Proposed modifications to the 125 ton crane for the spent fuel cask handling.....

PLANT NAME: H.B. Robinson

H. B. ROBINSON UNIT NO. 2
 LICENSE DPR-23
SPENT FUEL CASK HANDLING

RESPONSE TO AEC QUESTIONS - SEPTEMBER 25, 1974

REDUNDANT HOOK & LOAD BLOCK

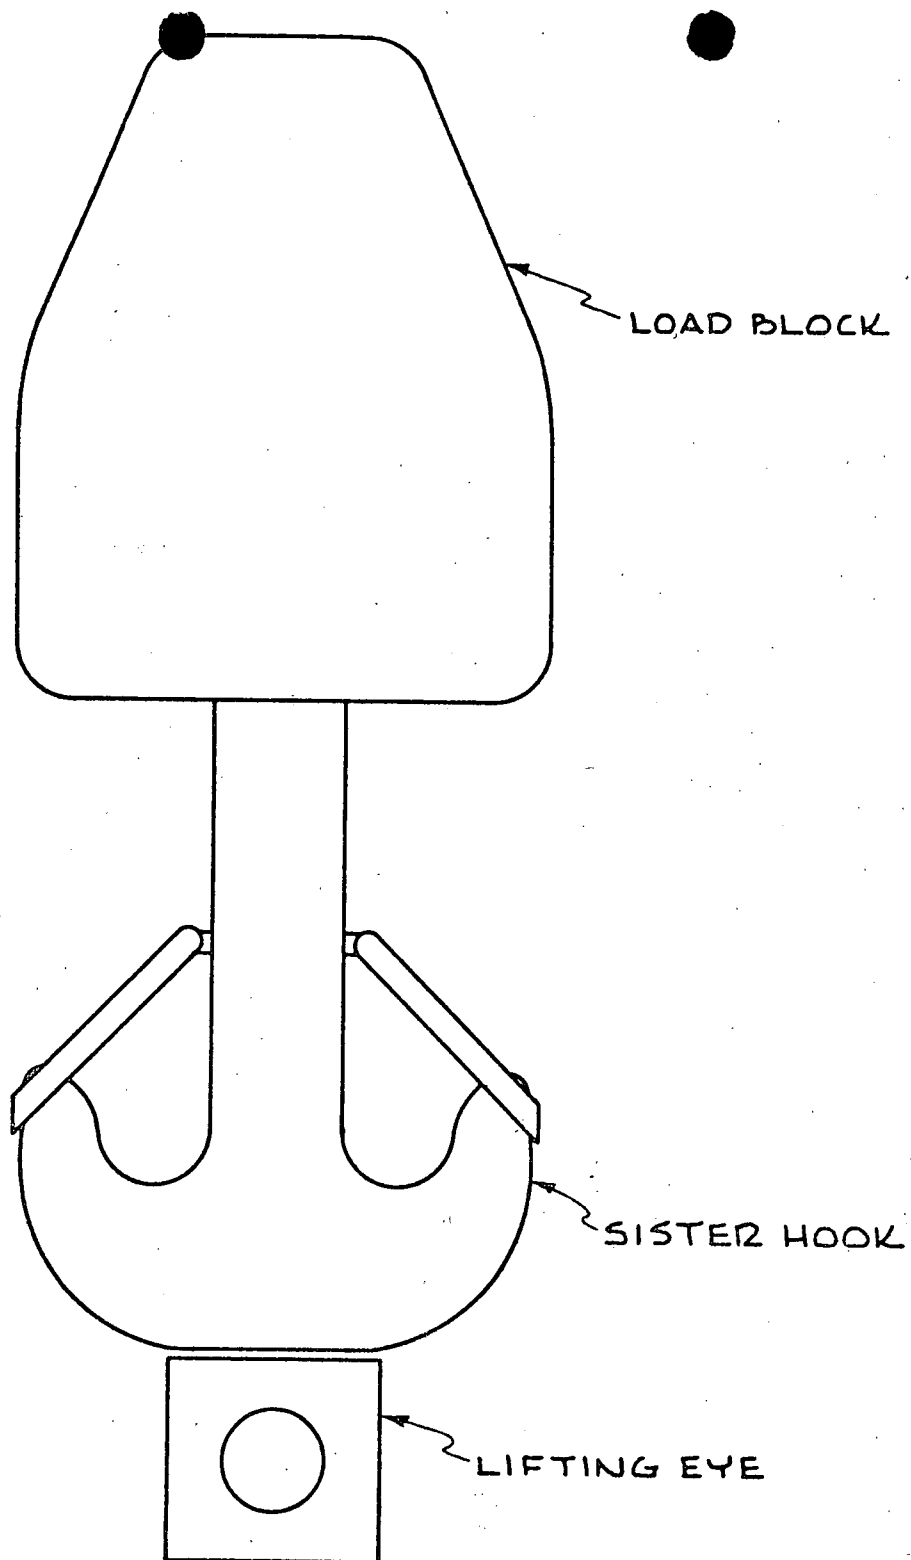
- (1) The Whiting Redundant Hoist System consists of a dual load path through the hoist gear train, the reeving system, and the hoist load block along with restraints at critical points to provide load retention and minimize uncontrolled motions of the load upon failure of any single hoist component. The system includes two complete gear trains connecting the single hoist motor to the hoist drum.

The load block provides a dual concentric pair of load connecting devices to carry the load into and through the block housing and sheaves, either of which has the ability to sustain the full load, while still providing normal load rotation capabilities. The normal load path is to the lower connector consisting of an "eye" similar to that found on the ordinary crane hook and capable of connection to any existing handling devices designed for such load connection. The upper device consists of a sister type crane hook also capable of supporting the full load which will accommodate secondary load connections such as slings or pinned links connecting to the load or handling device.

FIGURE 2
SHEET 1 OF 3

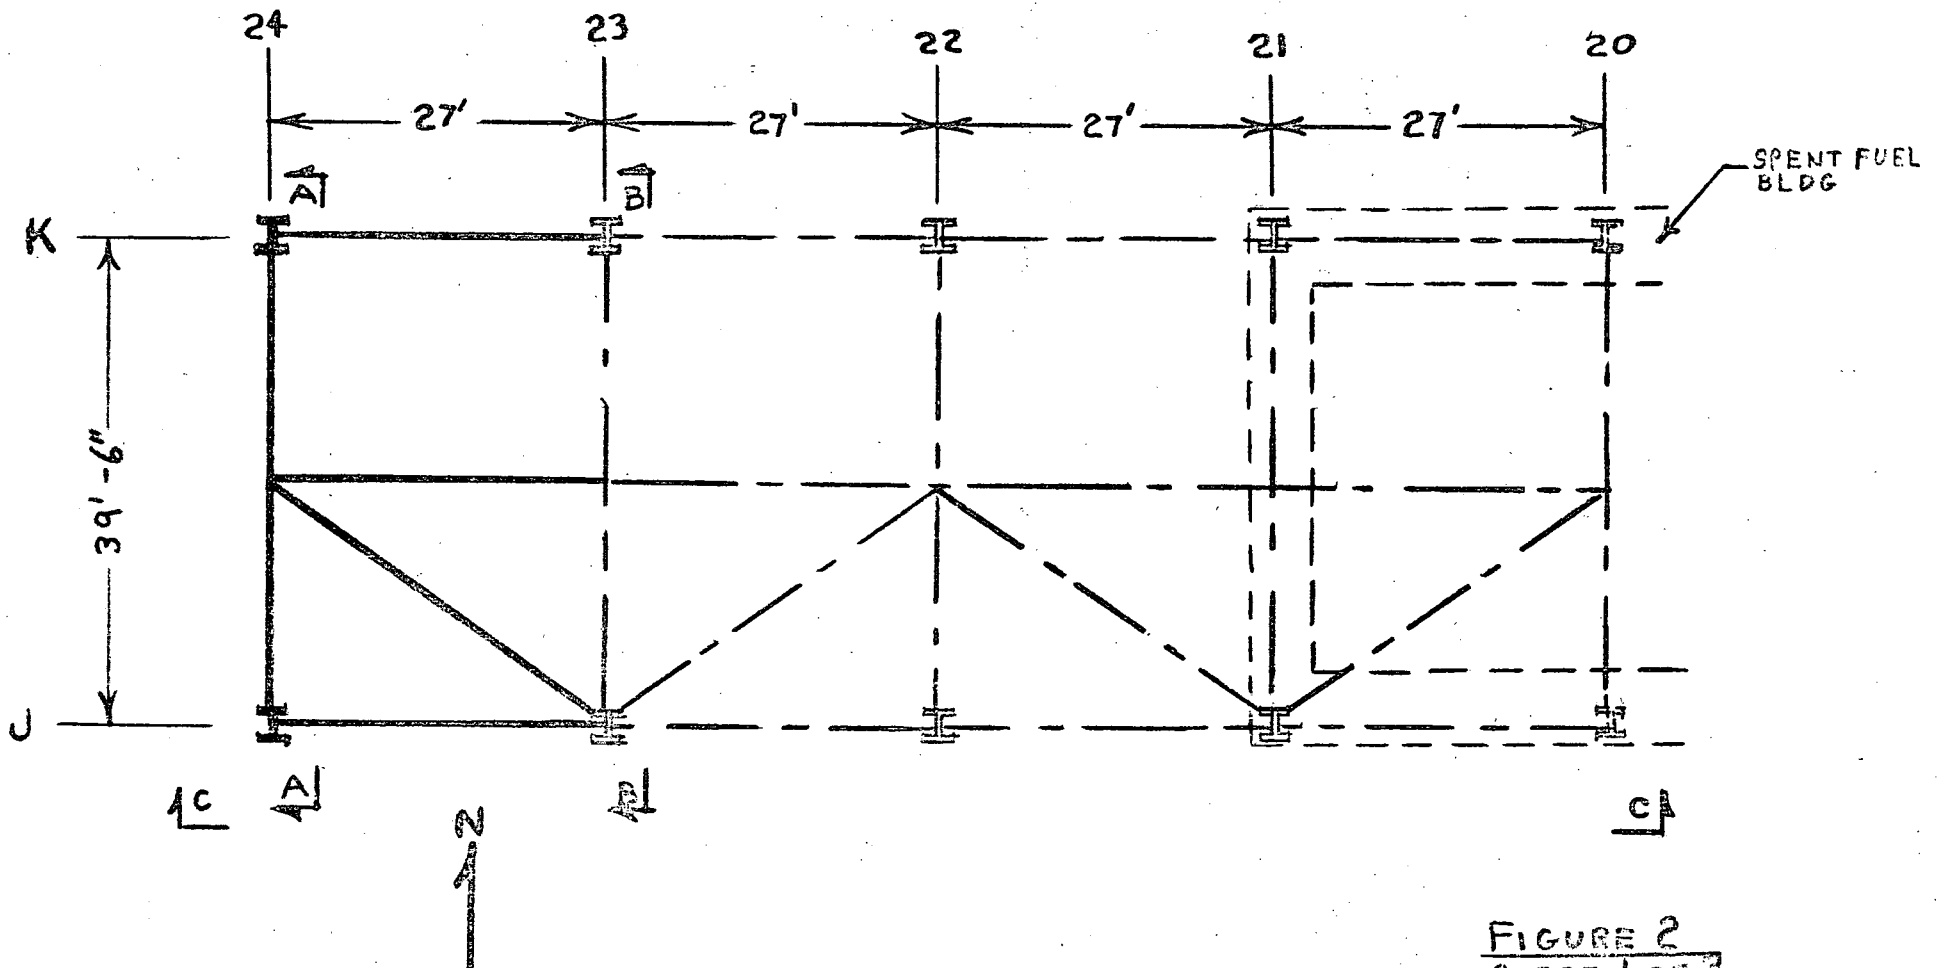
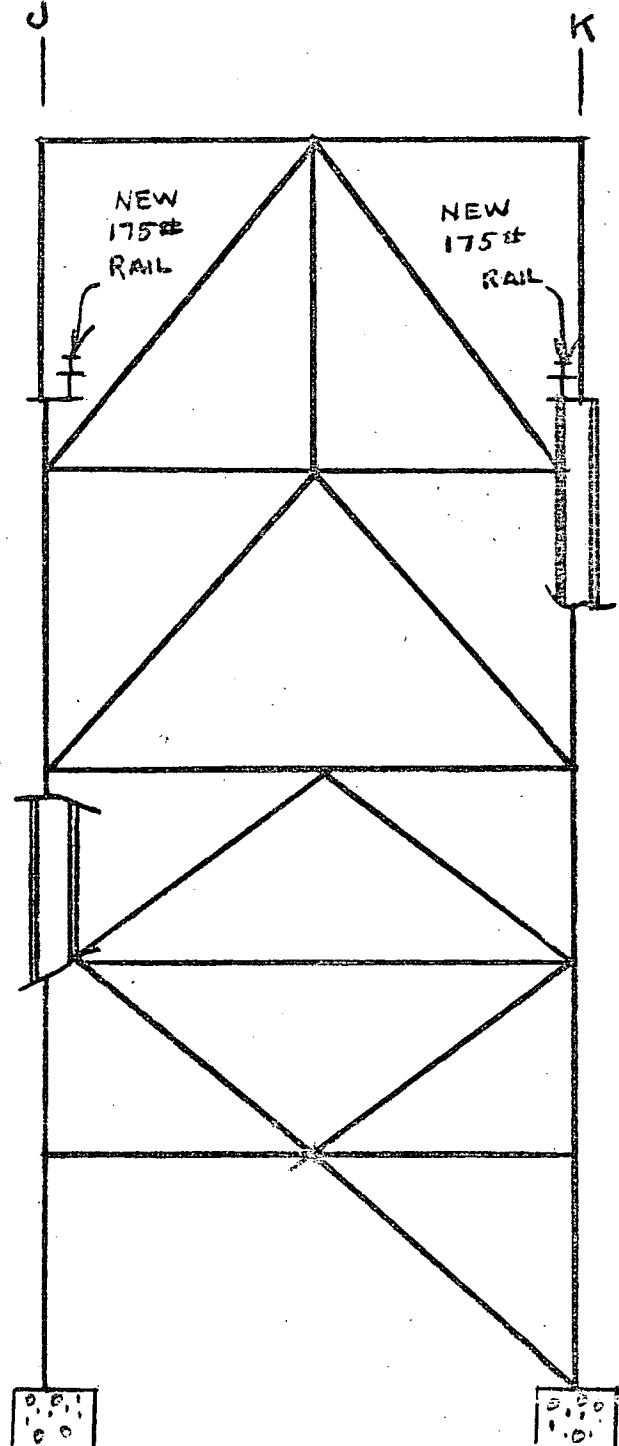
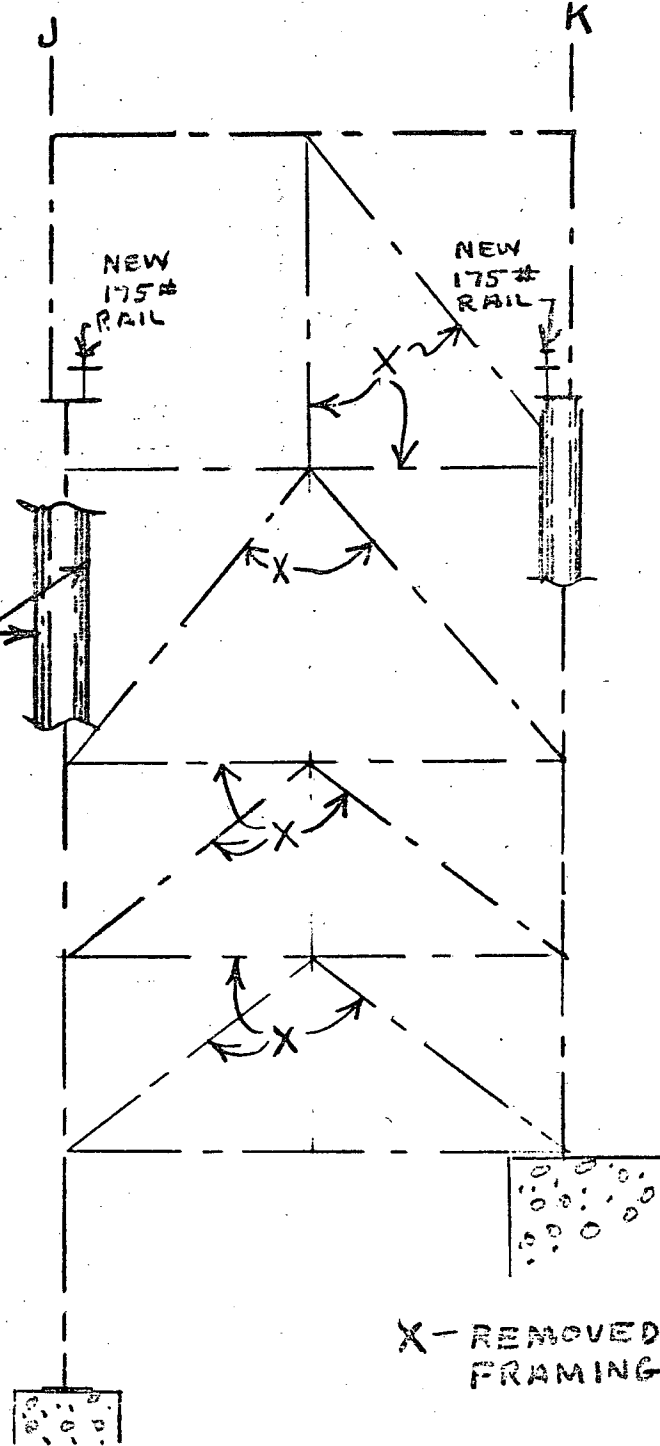
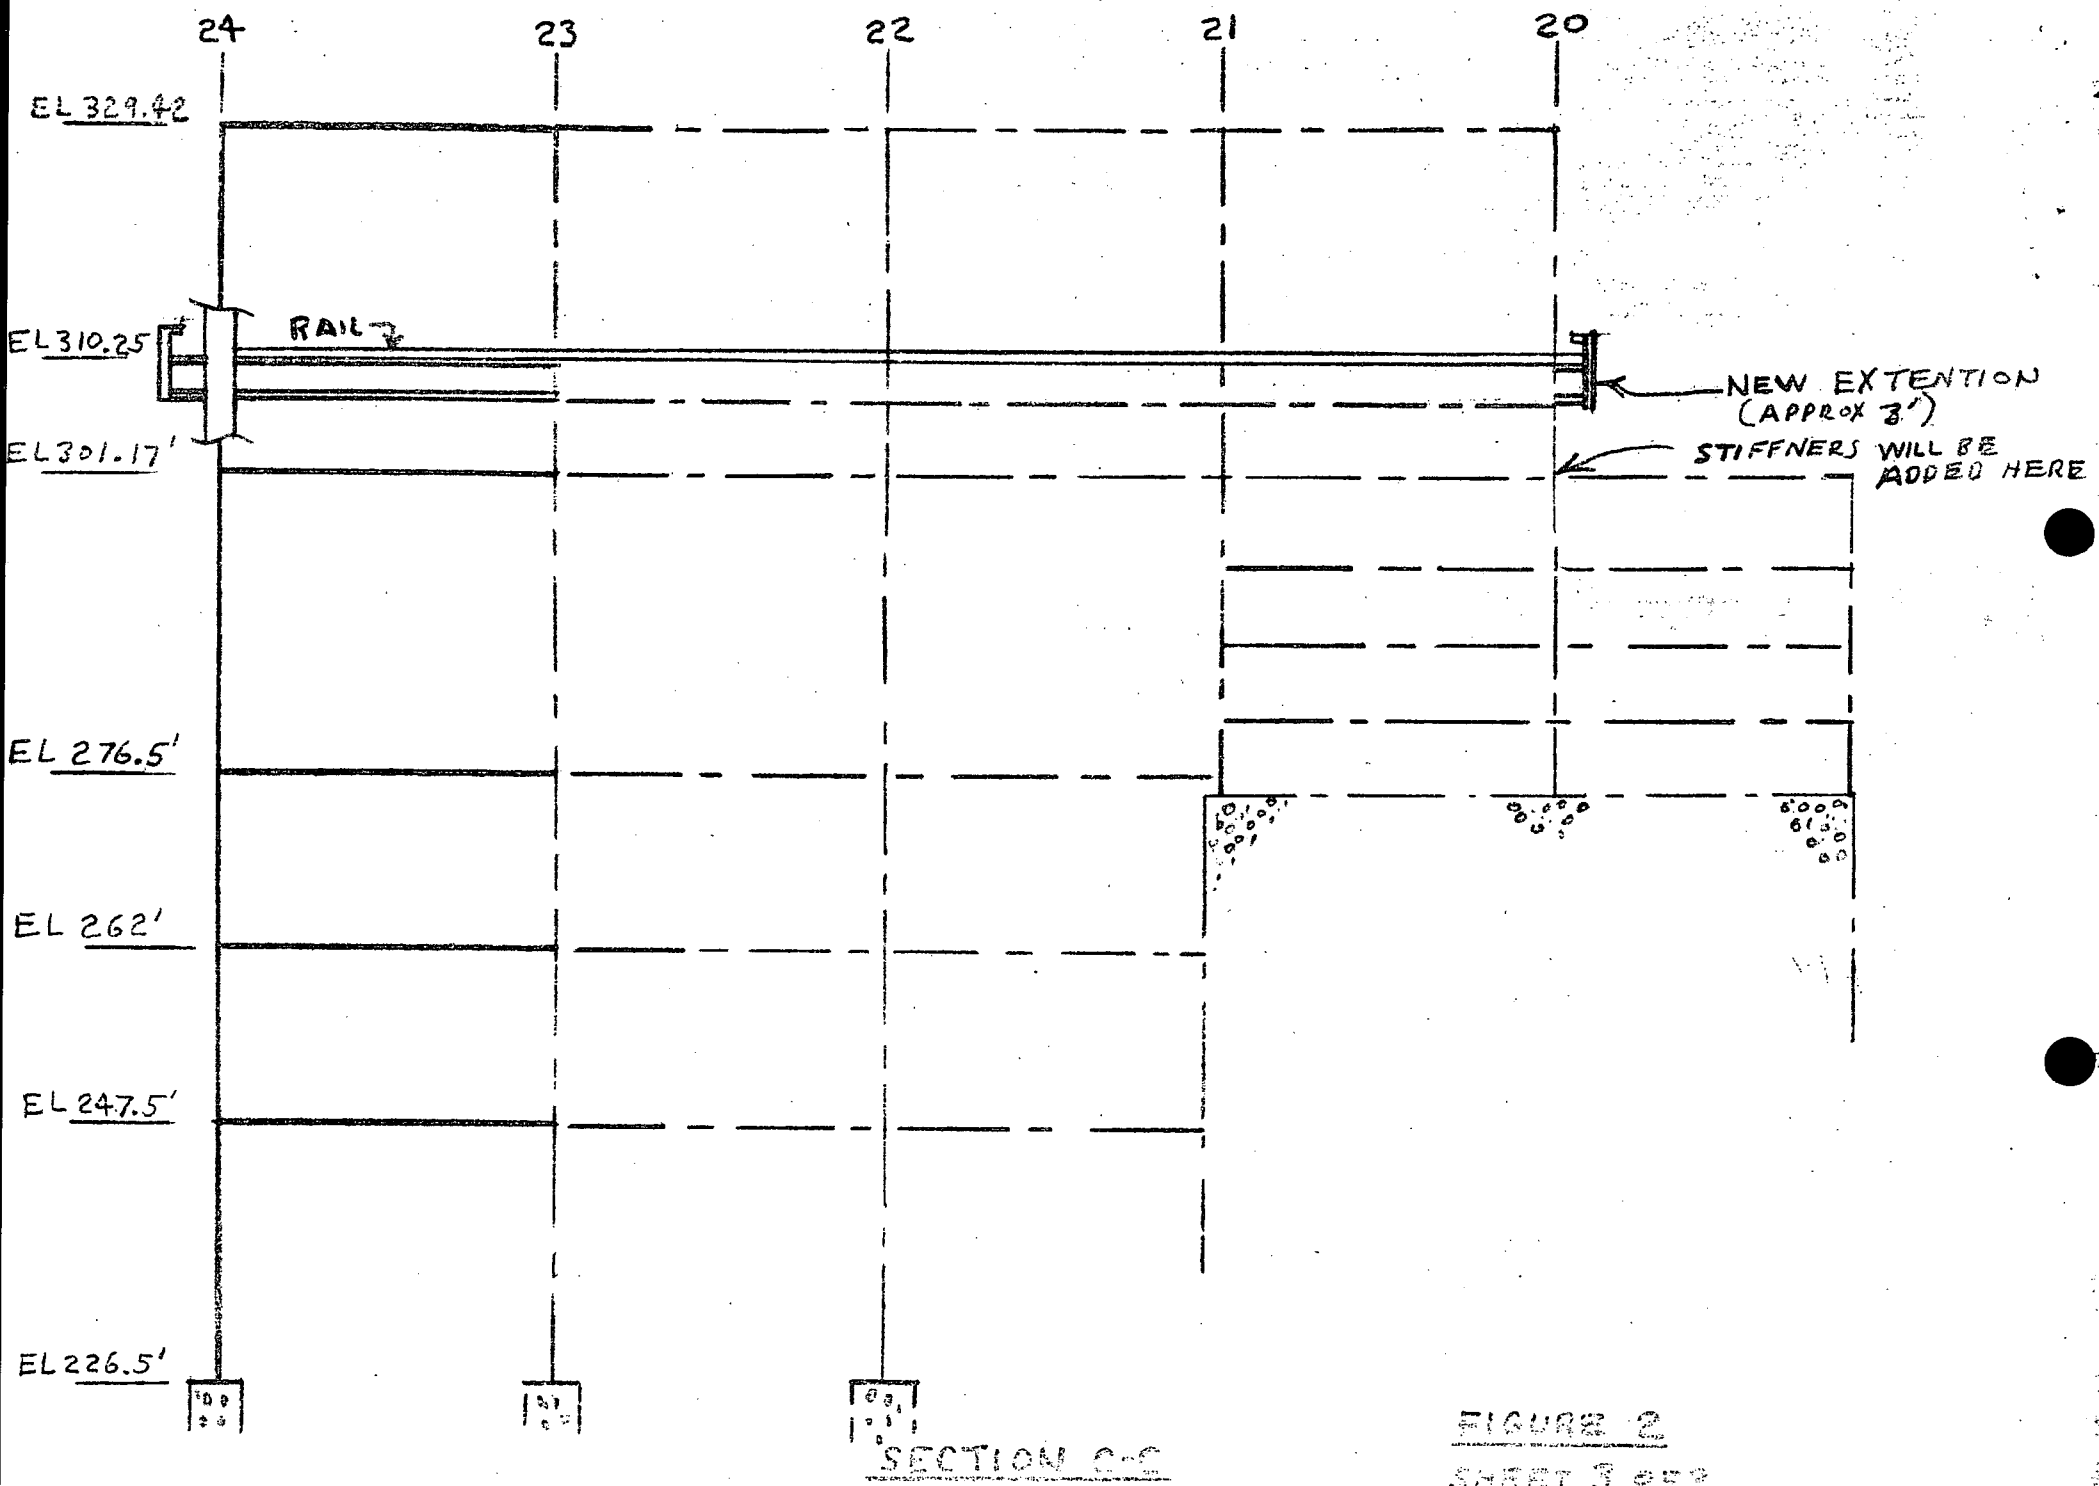
- (1) Upgrade capacity of existing structure for weight of new crane plus 125 ton lift load. Due to removal of end frames at column line 23, Columns 23 J and K will require stiffener plates welded the full length on both sides of each column. Columns 20 J and K will require stiffeners at elevation 301.17'. (See Figure 2 for locations.)
- (2) The runway will be extended one bay from Column Line 23 to Column Line 24 in the west direction to provide additional crane coverage necessary to erect a rail cask. The runway will be extended approximately 3 feet in the east direction to provide crane coverage over the center of the cask sit-down area in the spent fuel pool. (See Figure 2 for extensions.)
- (3) The existing 100 lb. rails will be replaced with 175 lb. rails to handle increased wheel loading.

- (1) Design, fabrication, material and erection are in accordance with AISC Manual of Steel Construction, 1963 Edition.
- (2) The basic wind loading is 30 psf.
- (3) Seismic loadings are 5% of the dead load.
- (4) Dead load is the dead weight of the crane.
- (5) Horizontal forces are as follows:
 - (a) Lateral live load - 10% (Lift Load + Wt. of Trolley)
 - (b) Longitudinal live load - 10% (Dead Load + Lift Load)
- (6) The vertical impact load is 15% of the lift load.

The structure is fabricated of ASTM A-36 steel with a yield of 36,000 psi. The allowable unit stresses are less than those permitted by AISC. Stresses are based on combined loads determined in accordance with the design criteria listed in b.(2), (3), (4), (5), and (6) above.
